# Access Compliance Report

## Public Rights-of-Way

Intersection ID: 45242	Main Street: TALUS_TRACE_LN	Cross Street: KODIAK_CT	Location: NE
ADA ID: 72193802C64E	Ramp Type: Perp	Initial Pass/Fail: Pass	Overall Compliance: No
Severity Score: 5			
Codes/Mitigation Info/Possible Solution		Field Measurements/Component Compliance

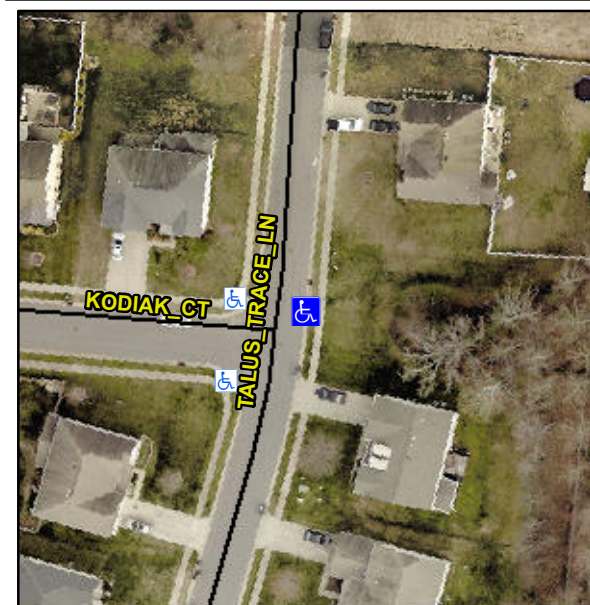
**Not Found, R304.2.1, R302.7,  
R304.5.4**

Compliance	Description	Data	Compliance	Description	Data
N/A	Ramp Length (in)	47.5	Yes	Ramp Slope (%)	7.8
Yes	Ramp Width (in)	48.0	Yes	Ramp XSlope (%)	0.3
N/A	Flare Type LT	Sloped	N/A	Flare Type RT	N/A
N/A	Flare Slope LT (%)	7.1	N/A	Flare Slope RT (%)	1.9
N/A	Flare Traversable LT?	No	N/A	Flare Traversable RT?	No
No	Landing Length (in)	47.0	Yes	DWS Provided?	Yes
Yes	Landing Width (in)	48.0	Yes	DWS Contrast?	Yes
Yes	Landing Slope (%)	1.2	Yes	DWS Length (in)	24.5
Yes	Landing X Slope (%)	1.8	Yes	DWS Full Width?	Yes
N/A	Landing Curb? (Y/N)	No	Yes	DWS Offset (in)	0.5
N/A	Shared Landing?	No			
No	Gutter Ponding?	Yes	No	Gutter Slope (%)	12.5
Yes	Gutter Lip Ht (in)	0.0	Yes	Gutter X Slope (%)	1.9
N/A	Painted X Walk1?	No	N/A	Painted X Walk2?	N/A
	X Walk 1 Direction	To W		X Walk 2 Direction	N/A
N/A	X Walk 1 Width (in)	N/A	N/A	X Walk 2 Width (in)	N/A
	X Walk 1 Slope (%)	1.8		X Walk 2 Slope (%)	N/A
	X Walk 1 X Slope (%)	1.6		X Walk 2 X Slope (%)	N/A

**Remove & Replace Entire Ramp.  
Remove & Replace Gutter.**
